**Notice of Allowability**

10/771,942

KIM ET AL.

FIG. 2  
(PRIOR ART)

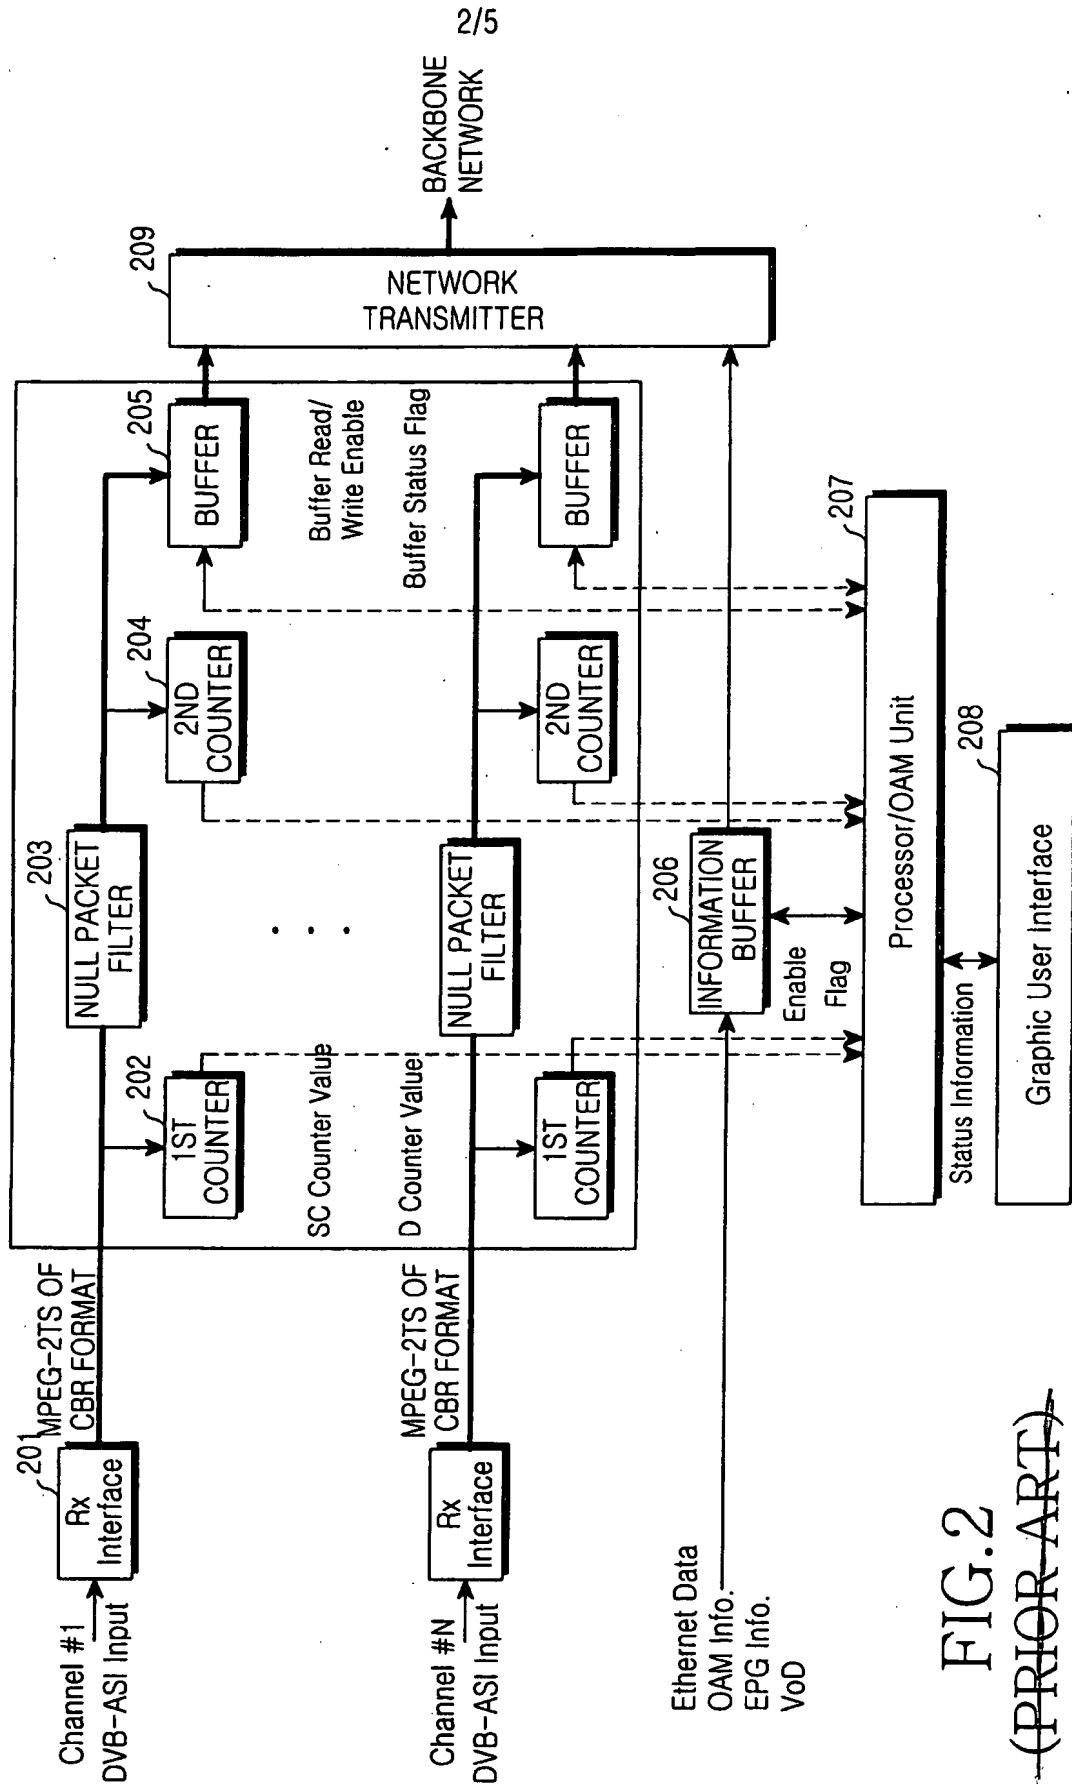
3. The following changes to the drawings have been approved by the examiner and agreed upon by applicant: The "PRIOR ART" label in fig. 2 has been deleted. In order to avoid abandonment of the application, applicant must make these above agreed upon drawing changes.
